# A TRANSNUCLEAR

July 2, 2004  
ANUH-01-04-05

**Subject:** Response to the Request for Additional Information (RAI) for Chapter A.4 and Submittal of Revision 2 of Application for Amendment No.1 of Advanced NUHOMS<sup>®</sup> Certificate of Compliance (CoC) No. 1029 for Dry Spent Fuel Storage Casks (TAC No. L23606)

**Figure A.4.7-8**  
**Maximum Fuel Cladding Temperature during Vacuum Drying Using Air for Blowdown**

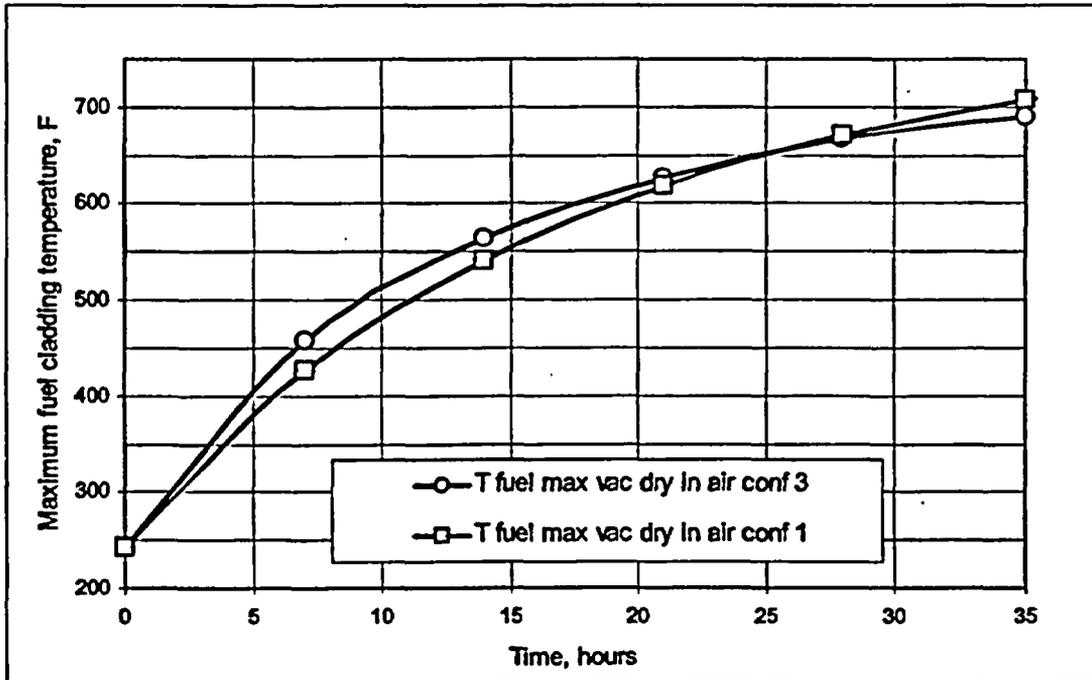
#### Question 4-7

In order to assure that known conditions exist at the start of blowdown and also the initial fuel clad temperature assumed is conservative for the vacuum drying transient, the DSC cavity will be filled with water, if needed, to assure that the initial cladding temperature is bounded by the 230°F annulus temperature used in the vacuum drying transient. Section A.8 of the SAR is revised accordingly to include this step in the operating procedure.

Figure A.4.7-8 has been updated to reflect the conservative starting temperature of 230°F. The predicted helium steady state temperature demonstrates that no time limit is required for the helium blowdown configuration. This analysis has been generated using the DSC CFD analyses. The model details are included in SAR Section A.4.4.4.
